Prairie Island Nuclear Generating Plant

**Supplement to License Amendment Request dated December 11, 2000
Conversion to Improved Technical Specifications (ITS)**

By letter dated, December 11, 2000, Prairie Island submitted a License Amendment Request (LAR) to convert the current Technical Specifications (CTS) using the guidance of NUREG-1431, Revision 1 as amended by NRC and industry Technical Specification Task Force (TSTF) documents. This letter supplements the subject LAR.

Figure 2.1.1-1 (page 1 of 1)
Reactor Core Safety Limits

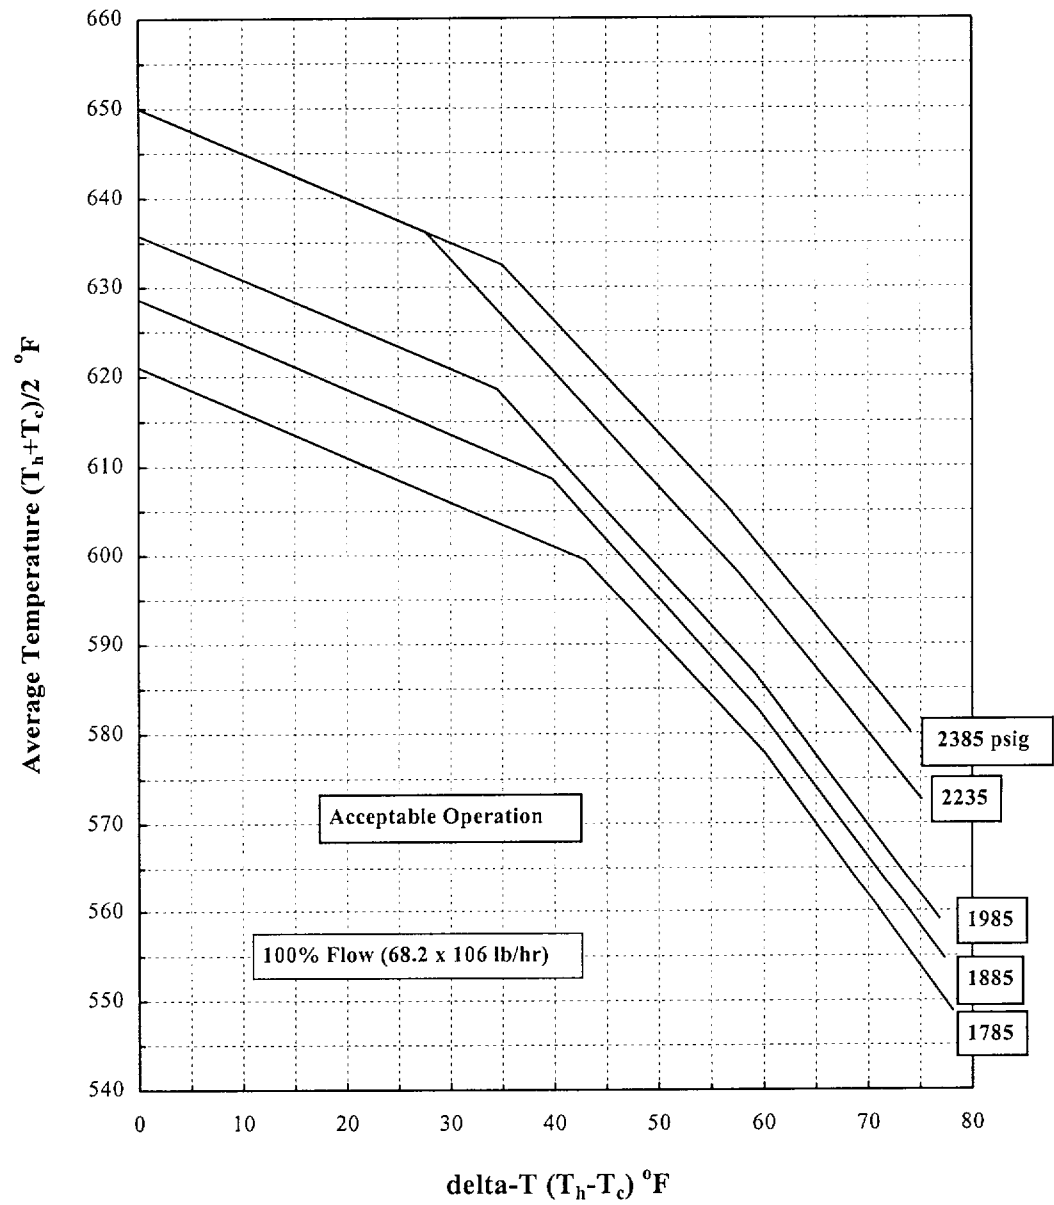
New Figure

The SL curves in Figure 2.1.1-1 define the regions of acceptable operation with respect to average temperatures, power (measured in ΔT), and pressurizer pressure. Each of the curves in the Figure has three slopes. For the 2235 and 2385 psig curves, at lower power (lower ΔT) the vessel exit design temperature, 650°F, is limiting. For the lower pressure curves, at lower ΔT , vessel exit temperature T_{sat} is limiting, to ensure the ΔT measurement remains valid. At all pressures after the first knee, at higher ΔT , the minimum DNBR derived from the critical heat flux correlation is limiting. The change in slope near full power ΔT is due to more restrictive $F_{\Delta H}$ consideration in the DNBR limit at high power.

Figure B 2.1.1-1 (page 1 of 1)
Reactor Core Safety Limits vs. Boundary of Protection

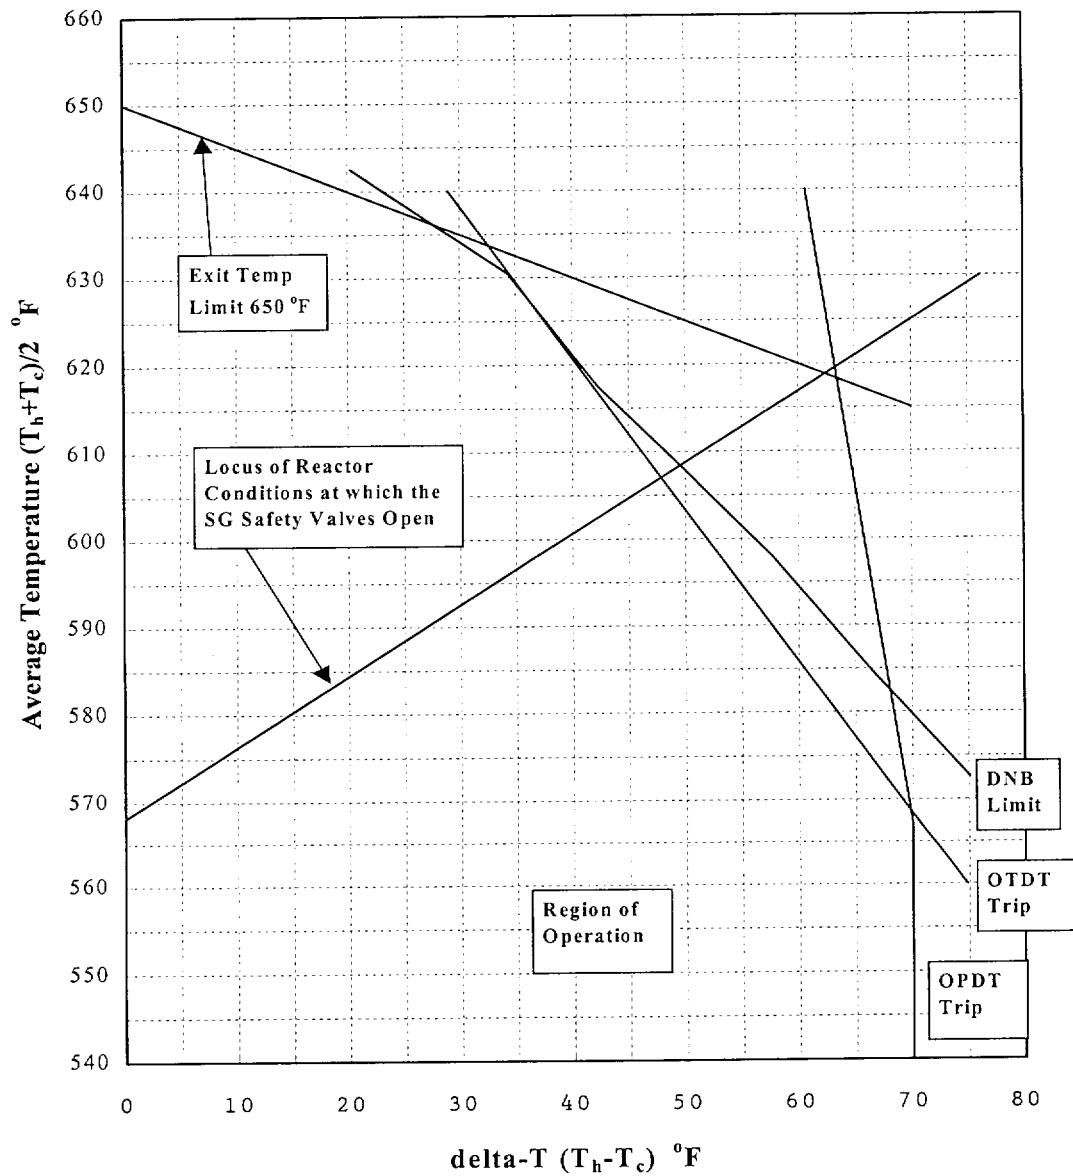
The curves are based on enthalpy hot channel factor limits provided in the CORE OPERATING LIMITS REPORT (COLR). The dashed line of Figure B 2.1.1-1 shows an example of a limit curve at 2235 psig. In addition, it illustrates the various RPS functions that are designed to prevent the unit from reaching the limit.

New Figure
